SCHMIDT PROPERTY RM-30 MAP AMENDMENT

LETTER OF INTENT

PCD File No. P-22-022

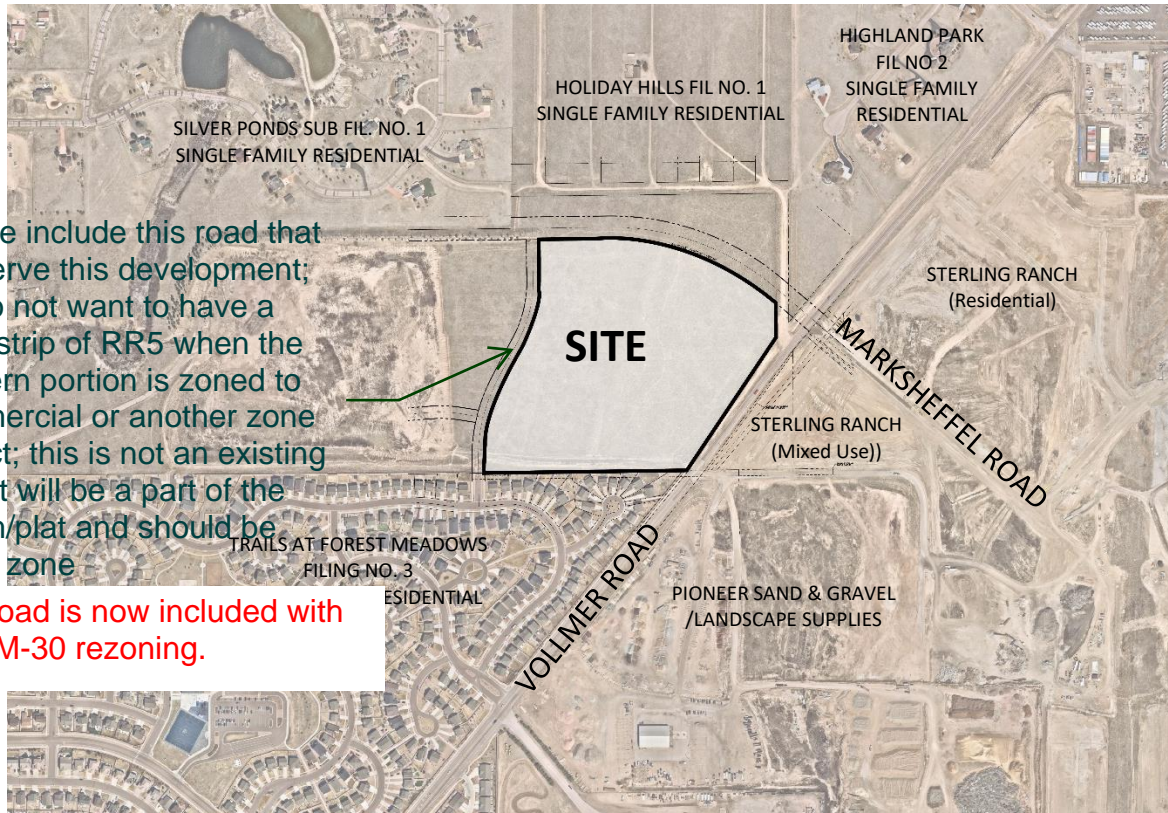
The legals and zone map do not match the assessors parcel configuration; has there been an illegal division of land? Please provide the recorded deeds creating the new parcels and the parcel numbers from the Assessor otherwise amend the application maps accordingly.

The legal shown on the rezoning exhibit reflects the portion of the larger parcel to be rezoned. Subdivision of the parcel will occur with platting.
